Amendment C231 Part 2 to the Yarra Planning Scheme
Comparison of *exhibited version* and the *version for adoption* and reasons for the change

Design and Development Overlay 16 (DDO16) – 390A Queens Parade, North Fitzroy

Attachment 3

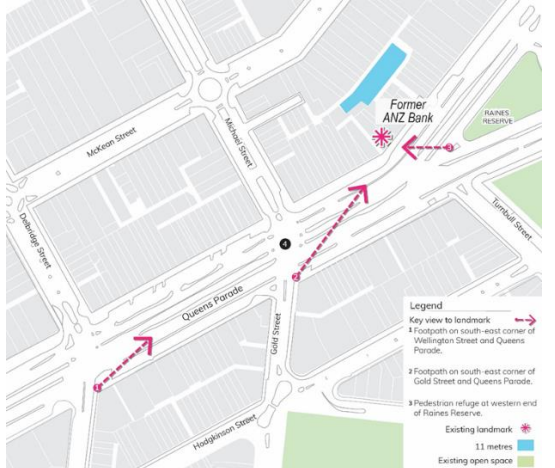
2.9 Interface to residential properties in NRZ or GRZ	Heading not included in the <i>exhibition version</i> .	<p>New sub-clause and heading added.</p> <p>The following new requirements are included:</p> <ul style="list-style-type: none"> <i>Development should respond to the low scale form of existing development through an appropriate transition in building height and setbacks to ensure reasonable standards of amenity.</i> <i>In Precinct 4, where sunlight to the secluded private open space of an existing dwelling is reduced, at least 75 per cent, or 40 square metres with minimum dimension of 3 metres, whichever is the lesser area, of the secluded private open space should receive a minimum of five hours of sunlight between 9 am and 3 pm on 22 September.</i> <p><i>If existing sunlight to the secluded private open space of an existing dwelling is less than the requirements of this standard, the amount of sunlight should not be further reduced.</i></p>	<p>In addition to changes to the side and rear setbacks, specific overshadowing controls were proposed in Precinct 3 and 4 in response to submissions.</p> <p>Submitters were concerned about the impacts of 4, 5 and 6 storey developments on the amenity of their properties to the south of the centre.</p> <p>Both requirements were relocated from Precincts 3 and 4 at the suggestion of the Panel – to reduce repetition.</p> <p>Requirement 1 which requires an ‘<i>appropriate transition to low adjoining low scale residential development</i>’ was supported by the Panel to address the interface with neighbouring residential properties.</p> <p>The purpose of the Requirement 2 is to protect adjoining residential properties from additional overshadowing at the equinox (the accepted urban design standard to apply when assessing overshadowing). The overshadowing requirements mirror ResCode Standards A14 and B21.</p>

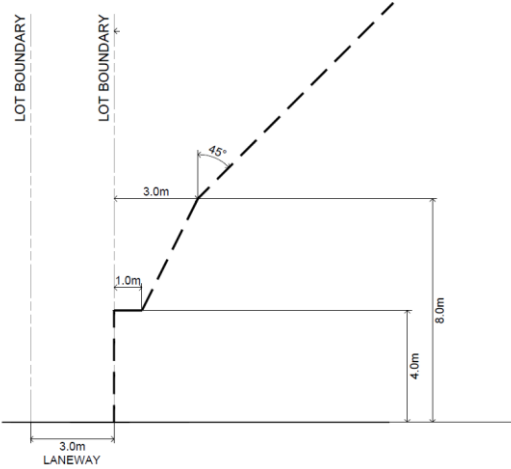
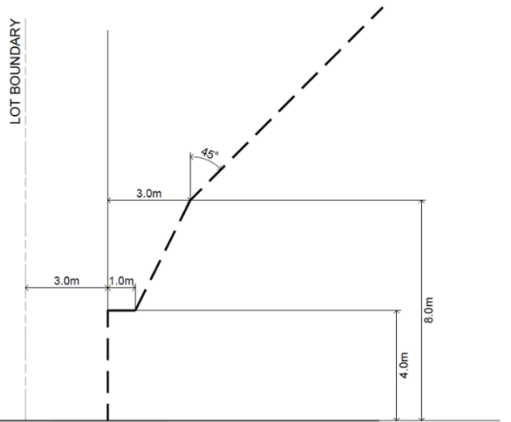
Reference documents	<p>Included:</p> <p><i>Queens Parade, Clifton Hill Built Form Review prepared by Hansen Partnership – December 2017.</i></p>	<p>Reference documents removed.</p>	<p>The Panel considered that some of the recommendations from the Built Form Review prepared by Hansen were no longer reflected in the amendment.</p> <p>The Panel agreed that the Built Form Review provided a catalyst and background for the amendment but not to the extent of being included as a Reference Document and recommended its deletion.</p> <p>The inclusion of the report as a Reference Document could create confusion in the future. Its deletion avoids that confusion.</p>
Figures 1 and 2	<p>Not included</p>	<p>Added:</p>	<p>As discussed above, side and rear setback requirements were amended for Precinct 4.</p>

Requirement	Exhibited DDO	Version of DDO for adoption	Reason for change
<p>Figures 1 and 2 (cont.)</p>		<p>Figure 1 - Setback where there is a laneway to the side or rear</p>  <p>Figure 2- Setback where there is no laneway to the side or rear</p> 	<p>Submissions received during exhibition were concerned about residential amenity and suggested that the ResCode B17 setback was a better alternative.</p> <p>Amended controls based on B17 were proposed. Figures 1 and 2 illustrate the side and rear setbacks. They are a modified version of the ResCode B17 standard, amended to accommodate a 4 metre ground floor.</p> <p>Figure 1 applies where there is a laneway at the rear and Figure 2 applies where there is no laneway – it requires an additional 3 metre setback to provide the separation offered by a laneway.</p> <p>The Panel supported this change to the DDO.</p>
